**ADDENDUM NO. 1**

**ANNUAL CURB & GUTTER REPLACEMENT FOR STREET RESURFACING  
CIP NO. 15509**

DWG NO.  
**ADD1**

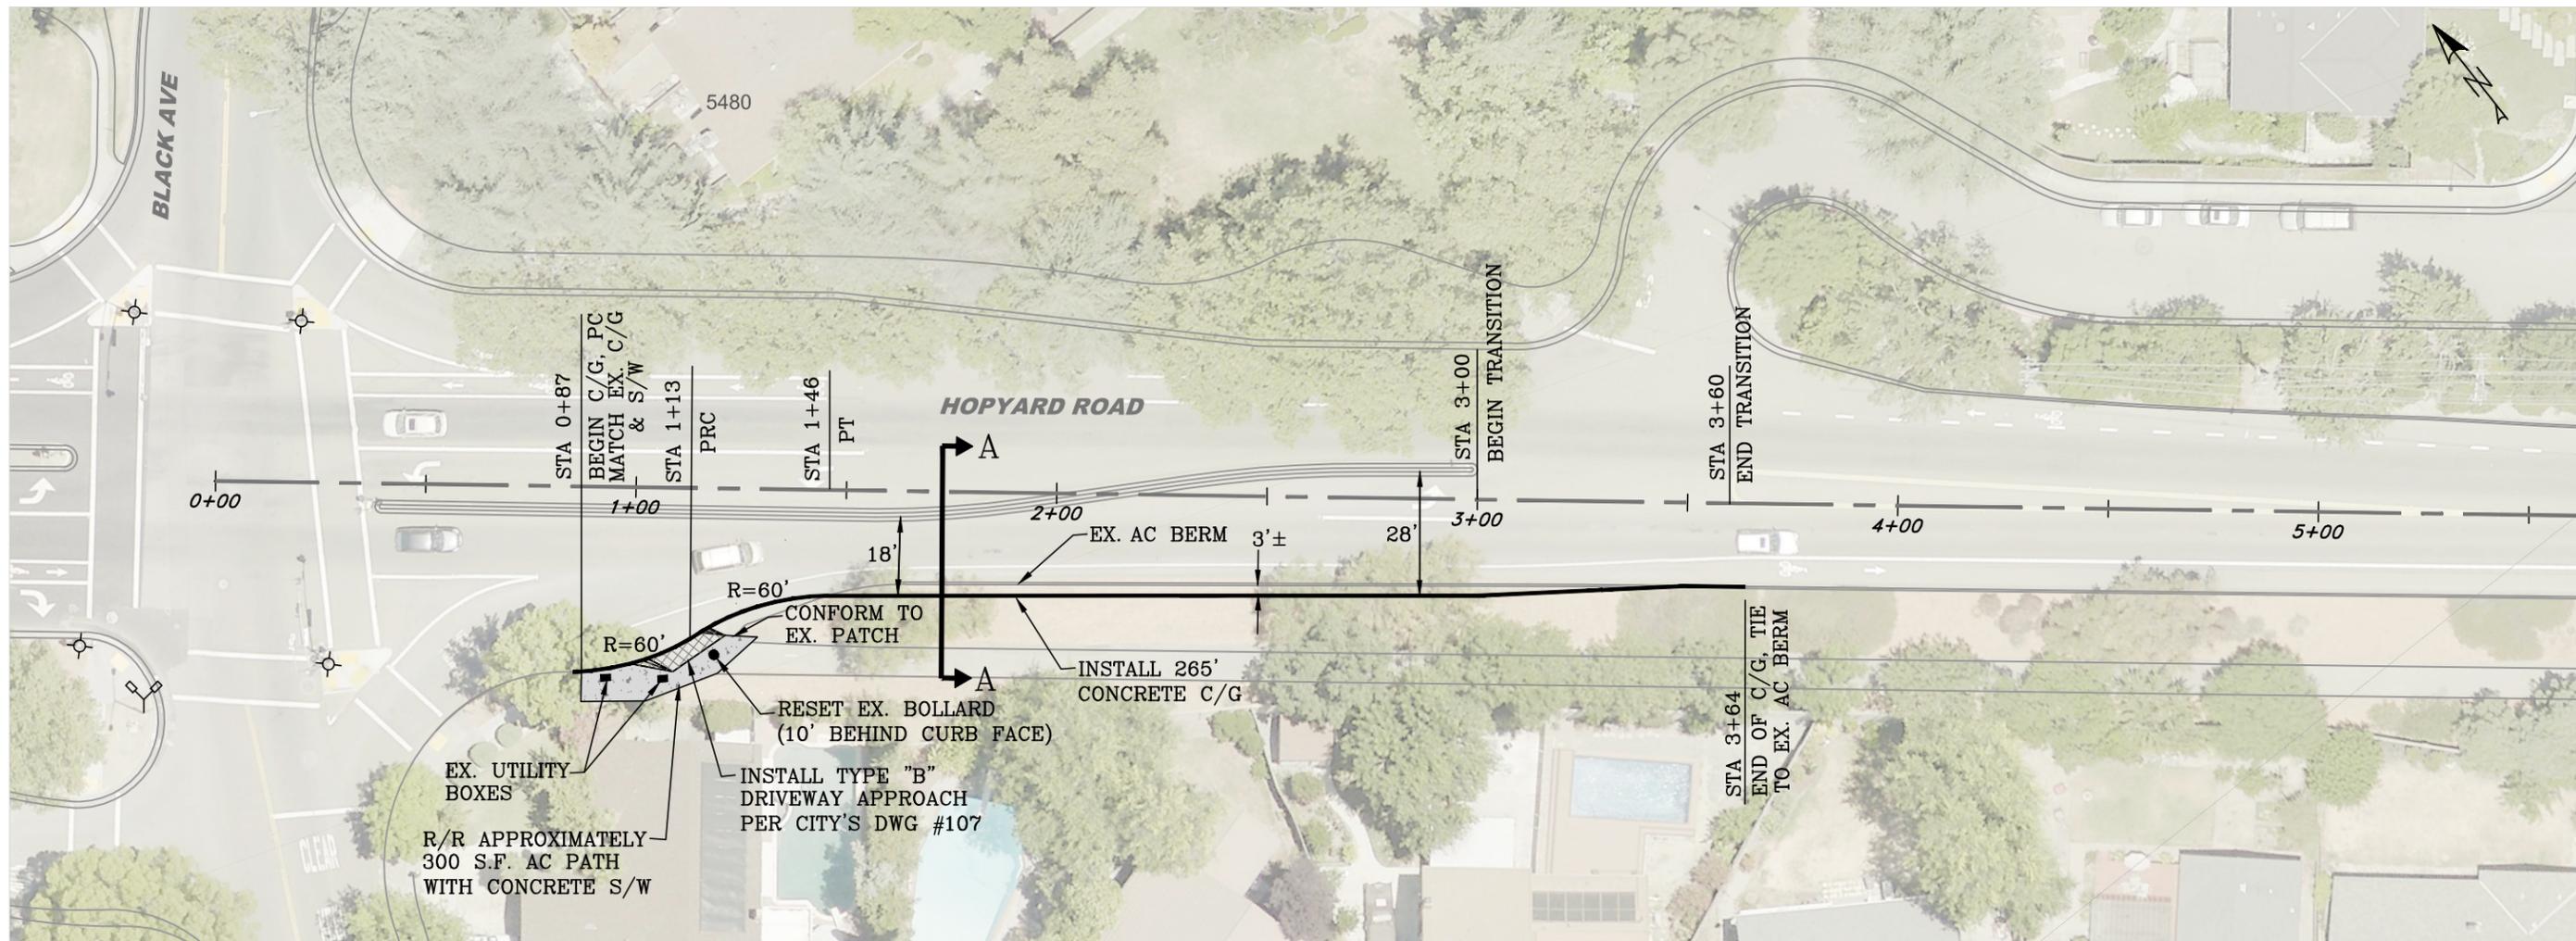
- 2) Include the attached sheet ADD 1, as part of the project plan.

REV.	DATE	DESCRIPTION
	11/16/16	ADDED WORK, ADDENDUM #1
